**Source:** TSG CT WG4  
**Title:** Corrections on Camel4  
**Agenda item:** 8.3  
**Document for:** APPROVAL

⌘ **23.078 CR 772** ⌘ rev - ⌘ Current version: **6.5.0** ⌘

<b>Title:</b>	⌘ Correction to No_Answer handling in CAMEL_ICA_MSC2		
<b>Source:</b>	⌘ Ericsson		
<b>Work item code:</b>	⌘ Camel4	<b>Date:</b>	⌘ 27 April 2005
<b>Category:</b>	⌘ <b>A</b>	<b>Release:</b>	⌘ Rel-6
<i>Use one of the following categories:</i>		<i>Use one of the following releases:</i>	
<b>F</b> (correction)		<b>Ph2</b> (GSM Phase 2)	
<b>A</b> (corresponds to a correction in an earlier release)		<b>R96</b> (Release 1996)	
<b>B</b> (addition of feature),		<b>R97</b> (Release 1997)	
<b>C</b> (functional modification of feature)		<b>R98</b> (Release 1998)	
<b>D</b> (editorial modification)		<b>R99</b> (Release 1999)	
		<b>Rel-4</b> (Release 4)	
		<b>Rel-5</b> (Release 5)	
		<b>Rel-6</b> (Release 6)	
		<b>Rel-7</b> (Release 7)

Figure 4.90-1: Procedure CAMEL\_ICA\_MSC2 (sheet 1)

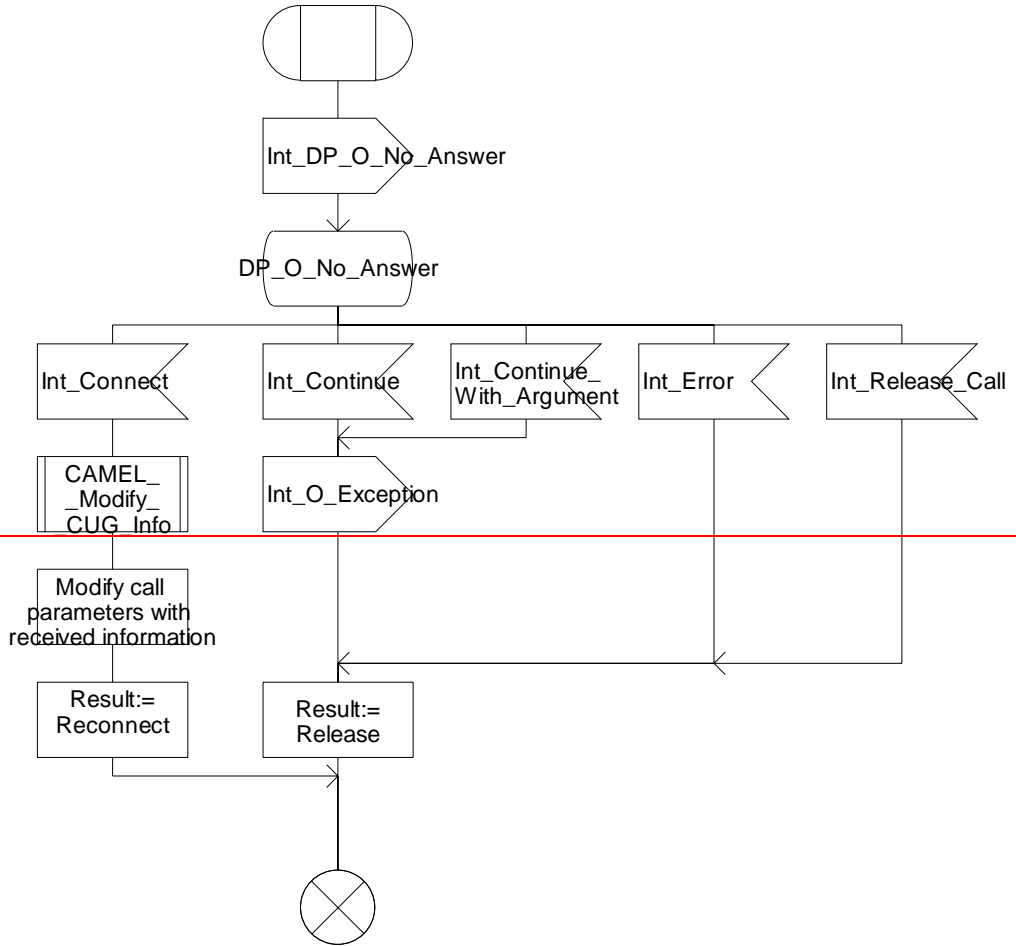
**Reason for change:** ⌘ Procedure CAMEL\_ICA\_MSC2 in section 4.5.6 (Handling of gsmSCF initiated calls) contains a superfluous Int\_O\_Exception signal.

There is no rationale for sending this Int\_O\_Exception after reporting a No Answer condition for an ICA leg (Procedure CAMEL\_ICA\_MSC2).

Hence, the Int\_O\_Exception signal from Procedure CAMEL\_ICA\_MSC2 should be removed. This is especially true since the gsmSSF process that is controlling the ICA leg for which the No Answer event occurs, may be controlling other ICA legs as well (an ICA leg may be moved to Call Segment 1 from Alerting onwards). Hence, when No Answer event occurs on one ICA leg and the gsmSCF responds with CAP Continue on the EDP-R event for that leg, then the gsmSSF process may remain active for the purpose of controlling the other legs in Call Segment 1.

**Summary of change:** ⌘ Correct figure **Error! Reference source not found.** 1-1: Procedure CAMEL\_ICA\_MSC2 (sheet 1) as described above.

Figure 4.90-1: Procedure CAMEL\_ICA\_MSC\_ALERTING (sheet 1)

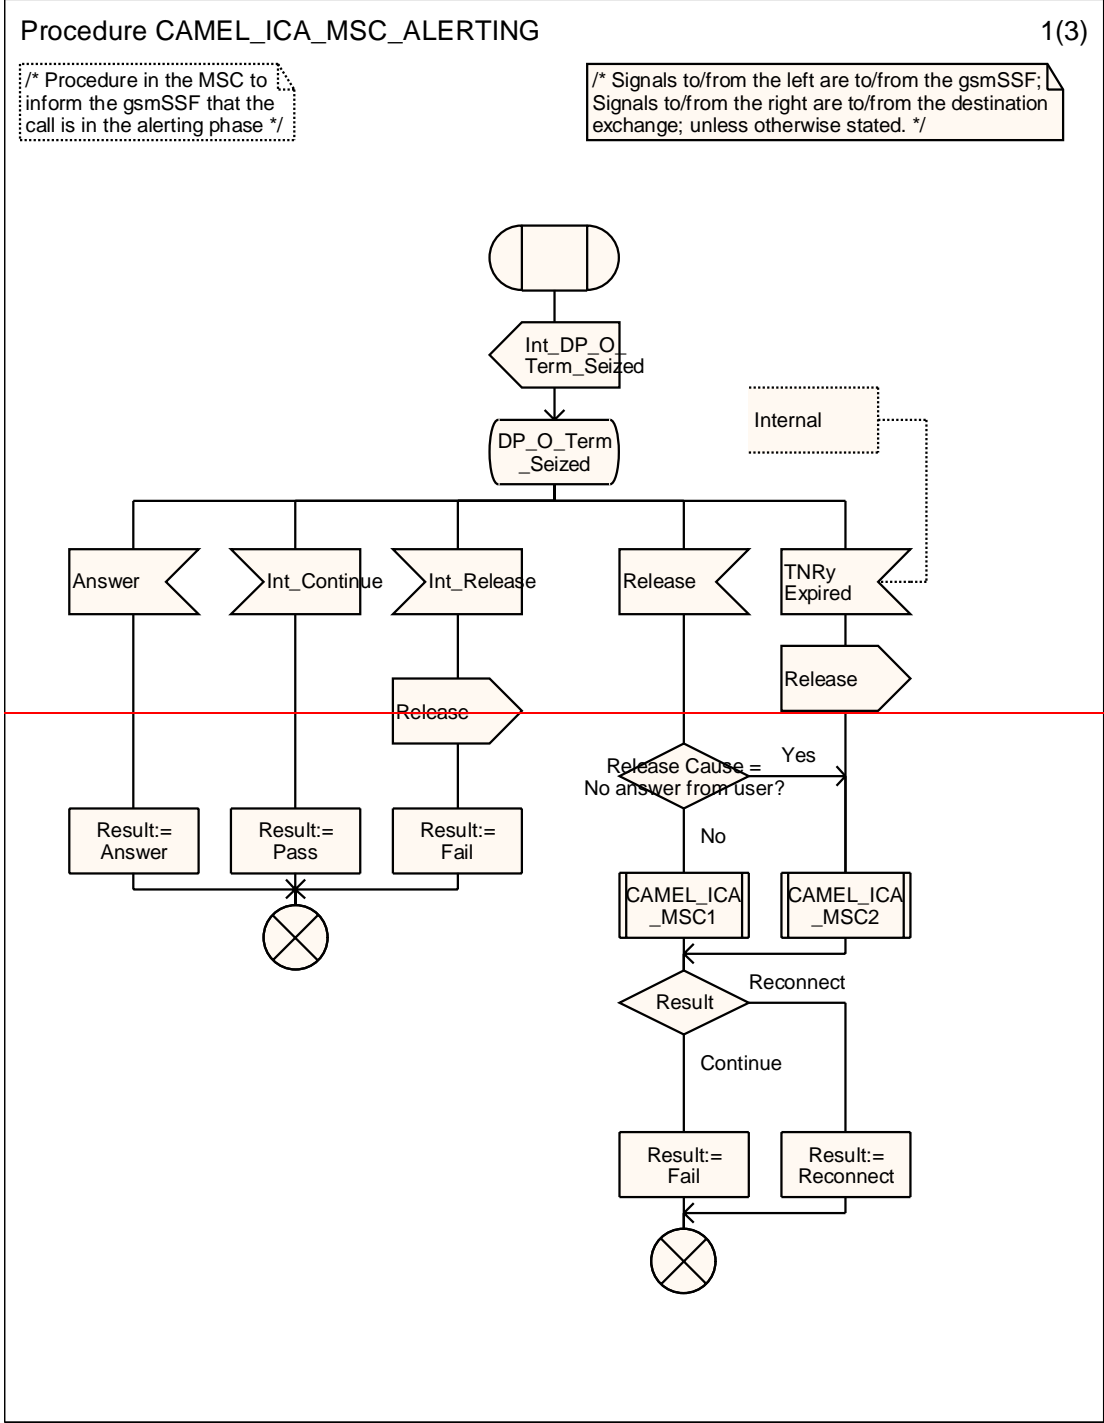
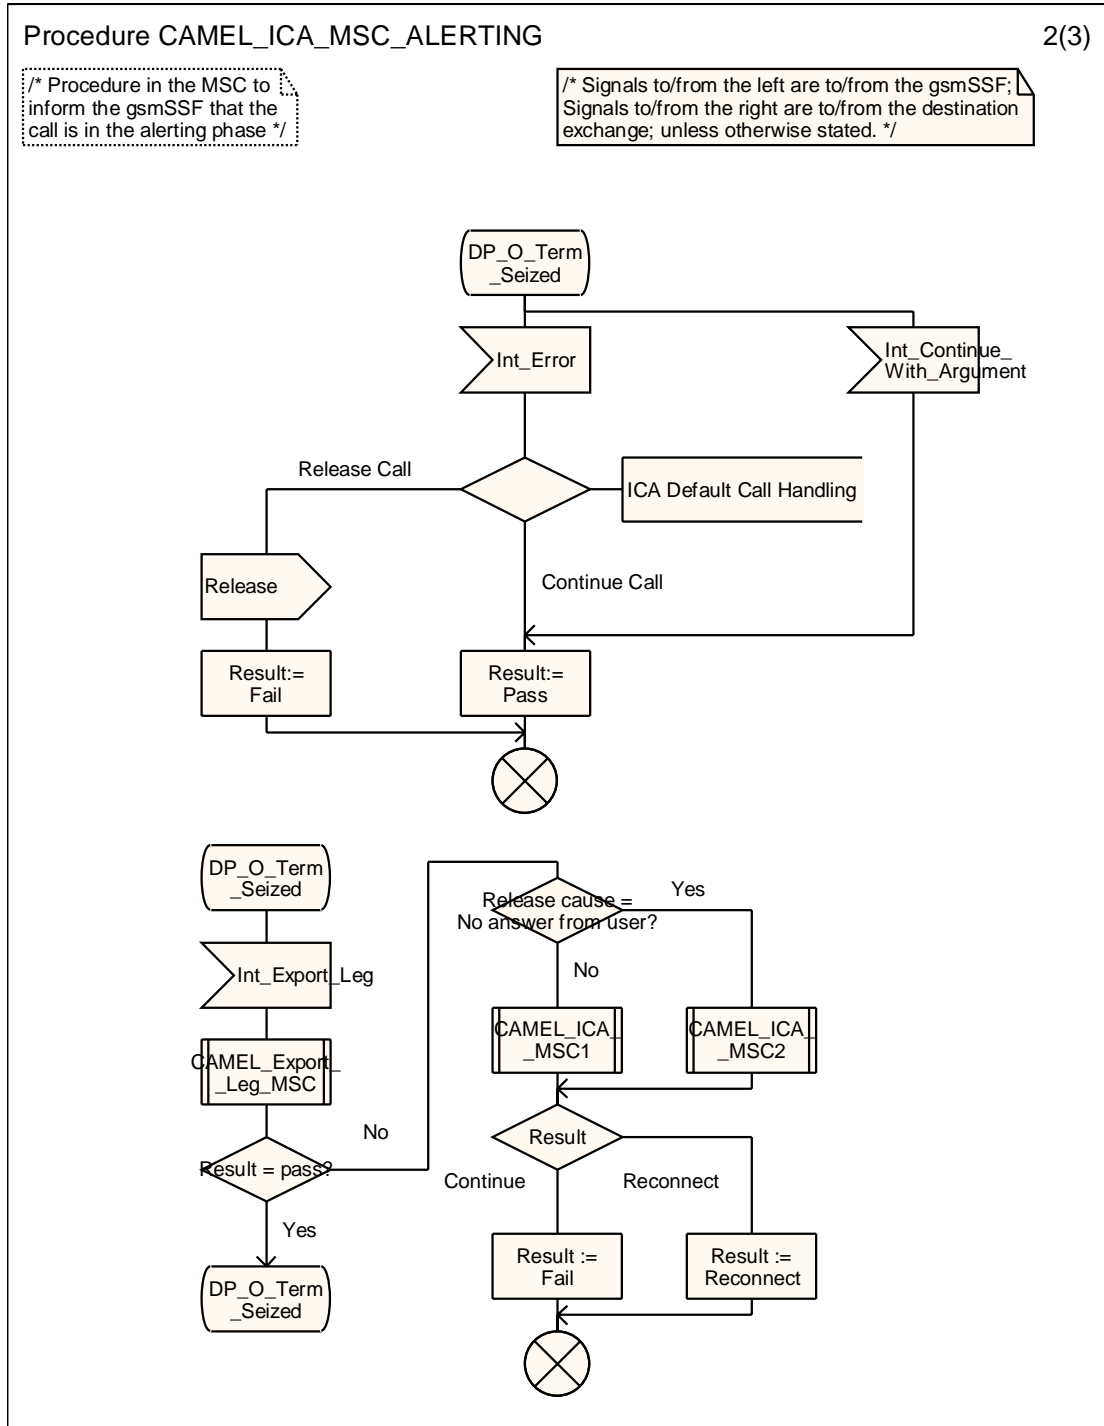
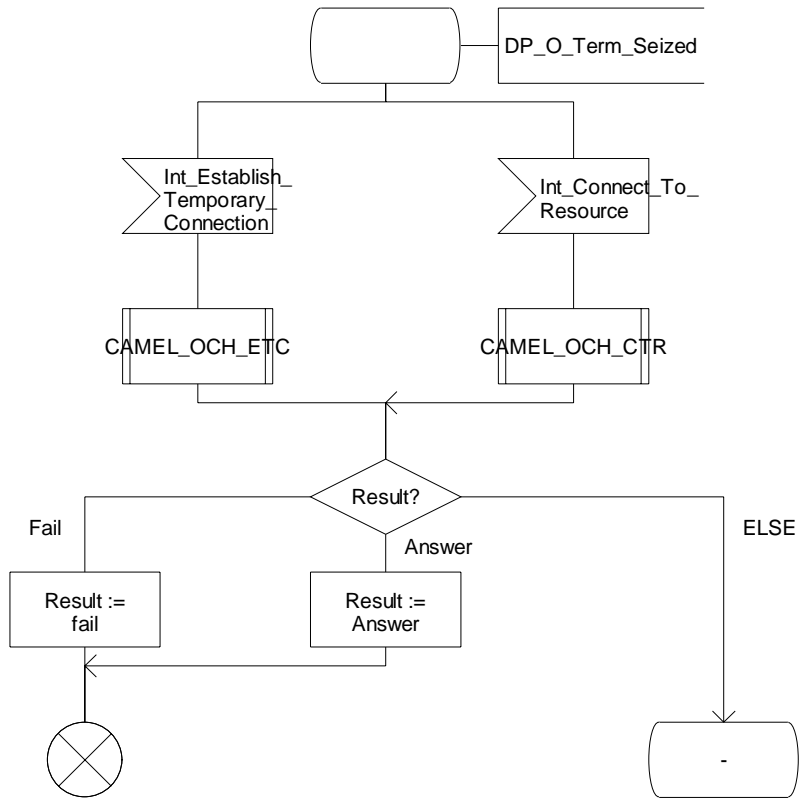
The procedures CAMEL\_ICA\_MSC\_ANSWER, CAMEL\_ICA\_MSC\_ALERTING, CAMEL\_ICA\_MSC1 and CAMEL\_ICA\_MSC2 in section 4.5.6 (Handling of gsmSCF initiated calls) need correction.

<p>CAMEL_ICA_MSC2 would actually need this check “<i>gsmSSF invoked?</i>”.</p> <p>For the same reason, the procedures CAMEL_ICA_MSC_ANSWER, CAMEL_ICA_MSC_ALERTING need the check “<i>gsmSSF invoked?</i>”.</p> <p>When Disconnect occurs on an ICA leg, then procedure CAMEL_OCH_MSC_DISC2 is called. That procedure is specified in section 4.5.2 (Handling of mobile originated calls) and contains already the check for an active gsmSSF process.</p>
<b>Summary of change:</b> ⌘	Add the check <i>check “gsmSSF invoked?”</i> to CAMEL_ICA_MSC_ANSWER, CAMEL_ICA_MSC_ALERTING, CAMEL_ICA_MSC1 and CAMEL_ICA_MSC2 in section 4.5.6 (Handling of gsmSCF initiated calls).
<b>Consequences if not approved:</b> ⌘	Unnecessary signal is sent to the gsmSSF process that may not actually exist. Implementers may expect that call events like Busy, Answer etc. can always be reported to the SCP, which would cause unexpected behaviour.

Figure 4.92-1: Procedure CAMEL\_ICA\_MSC1 (sheet 1)

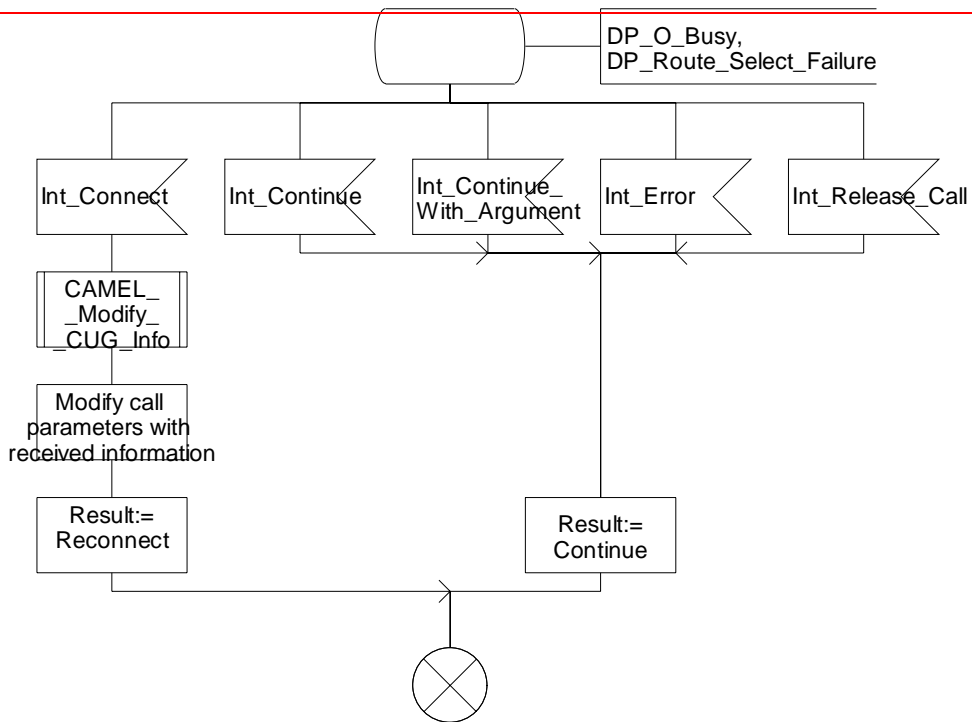
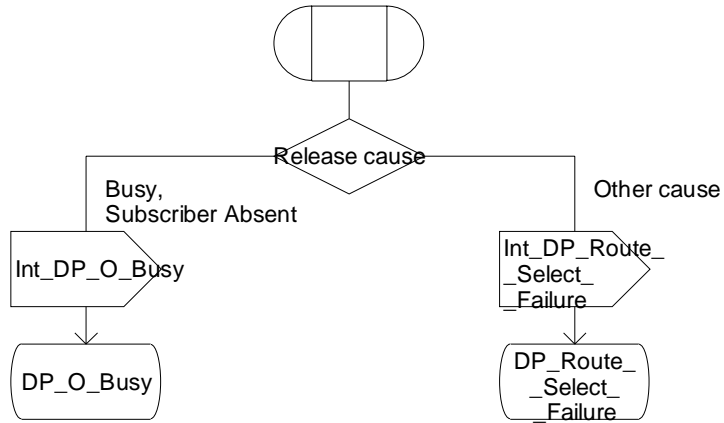
When an ICA leg is created, the gsmSCF is required to arm the call establishment failure DPs. As a result, the gsmSSF process for the ICA leg remains active during call establishment. Hence, when CAMEL\_ICA\_MSC1 or CAMEL\_ICA\_MSC2 is executed, as a result of the occurrence of a call establishment failure event, then it is not possible that there is no gsmSSF process active for that ICA leg. For that reason, procedures CAMEL\_OCH\_MSC1 and CAMEL\_OCH\_MSC2 don't check whether a gsmSSF process is active for that leg.

In the case of the ICA leg, we could, however, have the situation that the ICA leg is answered and then moved to Call Segment 1. Then later on, a follow-on call is generated for the ICA leg and the gsmSCF drops out of the call. So, there is no gsmSSF process anymore. In that case, CAMEL\_ICA\_MSC1 or

Figure 4.99-29: Process CS\_gsmSSF (sheet 29)

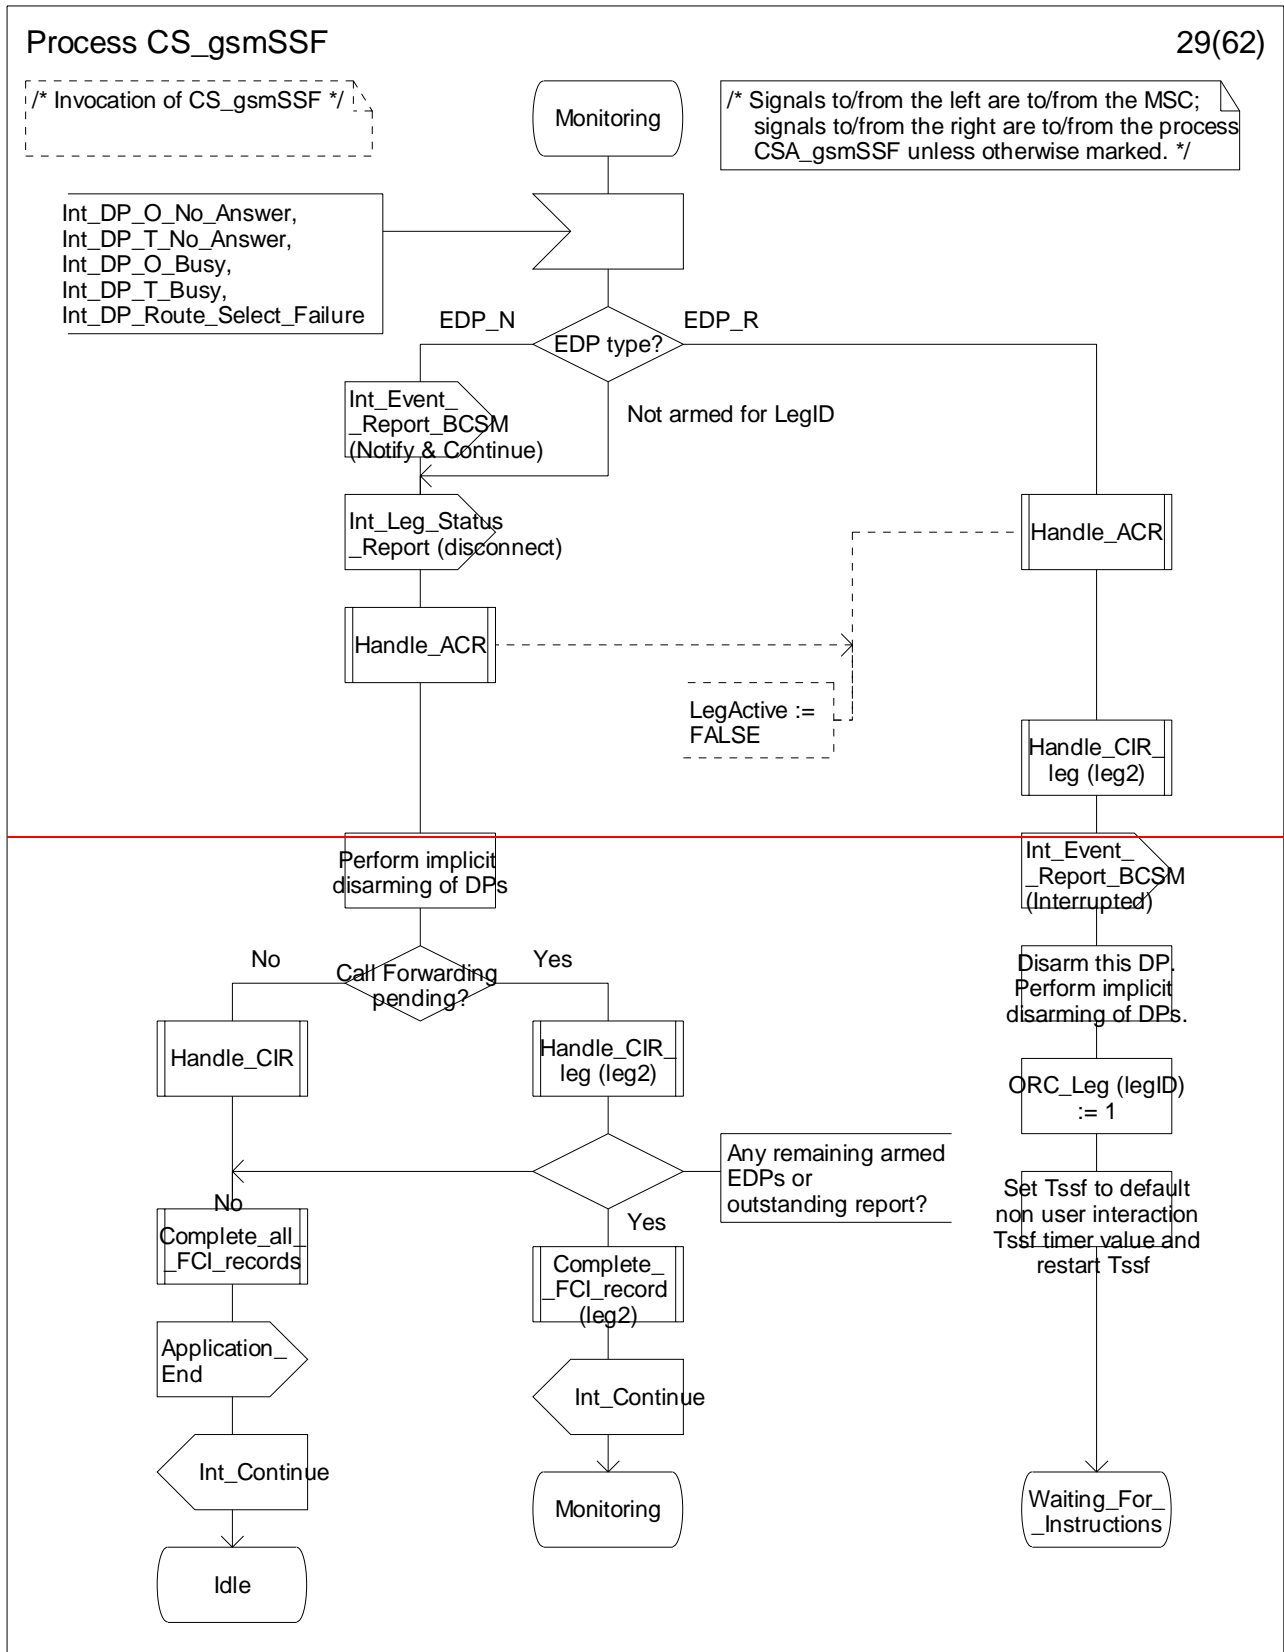
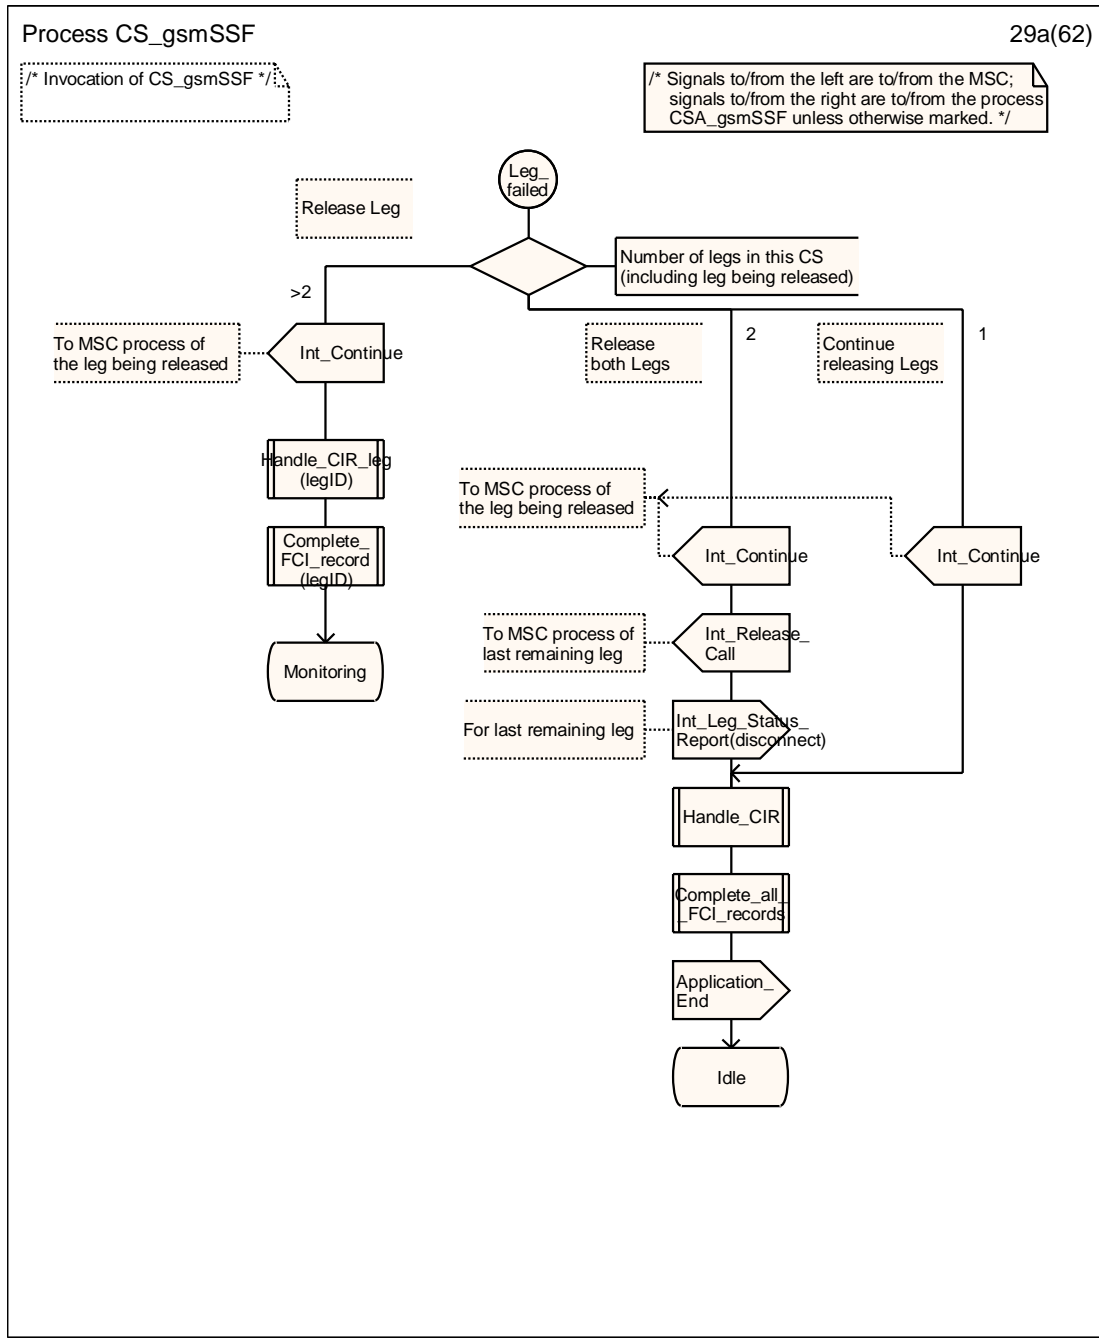
The handling of the call establishment failure events in process CS\_gsmSSF requires correction. It may happen that an ICA leg reaches the active state and is moved into Call Segment 1. Later on, a follow-on call is created for that ICA leg; the ICA leg is still in Call Segment 1. For this ICA follow-on call leg, the gsmSCF arms Busy, No\_Answer and Route\_Select\_Failure as EDP-N or does not arm these events at all. Meanwhile, there may still be other legs in Call Segment 1.

When the Busy event on the follow-on ICA leg occurs, the gsmSSF process will transit to Idle, even though there may be other legs in the Call Segment 1. For those other legs, the CAMEL control is now lost.

For CAMEL Phase 4, a check is required on the number of legs in the Call Segment; the number of legs in the call segment determines the action to be taken by the gsmSSF. This handling is already defined for the Disconnect case:

- if there are more than two legs in the Call Segment, then the failed leg is released and the other legs are retained;

- if there are two legs in the Call Segment, then the call will be released;
  - if there is one leg in the Call Segment, then the call will be released.
- This behaviour is required also for the call establishment failure case.

**Summary of change:** ⌘ Correct Process CS\_gsmSSF as described above.
